1610-1612 DENNIS STREET

A request for a conditional use approval to construct a 2-family duplex on property located within the Single Family (SF) zoning district pursuant to Sections 122-62 and 122-236 of the Land Development Regulations of the Code of Ordinances of the City of Key West, Florida.

ELEVATION - REAR

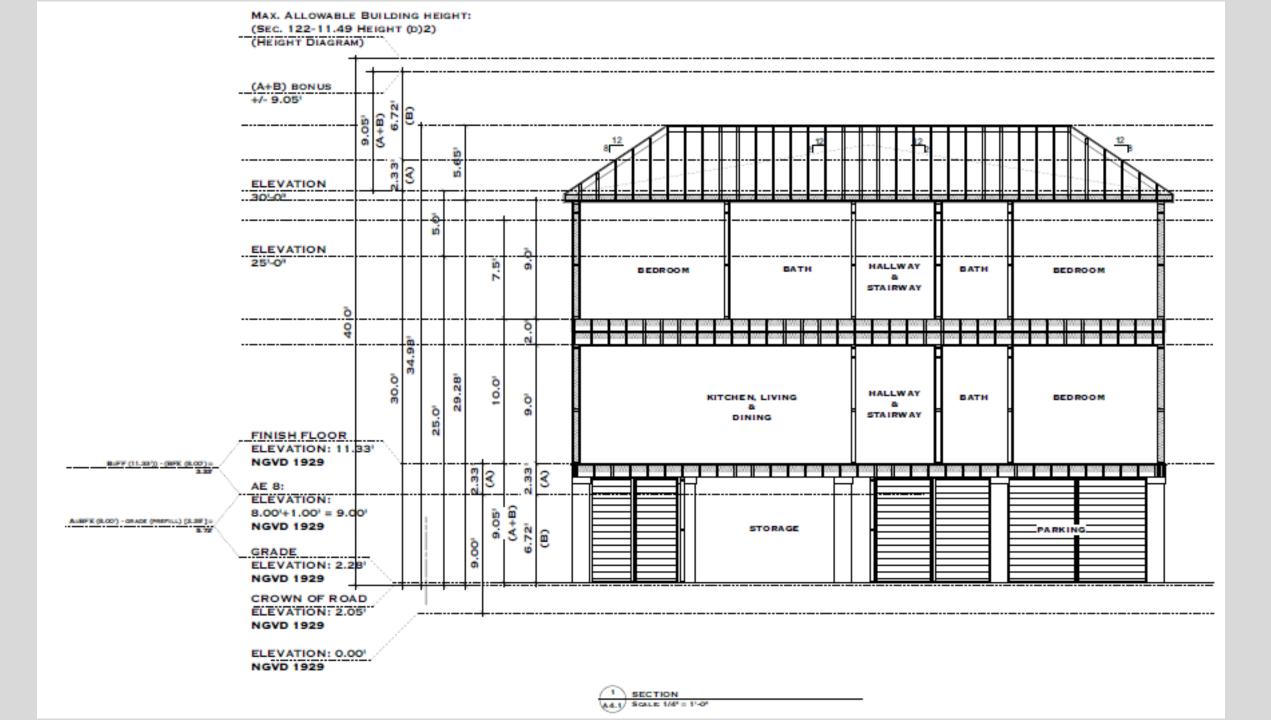
- 4. Per the Fire Department: The applicant is required to create a 5-foot access between the proposed trees on the Lot Mitigation Plan and the proposed staircase of the duplex and 7.7 feet of access between the proposed trees and the proposed overhangs of the duplex.
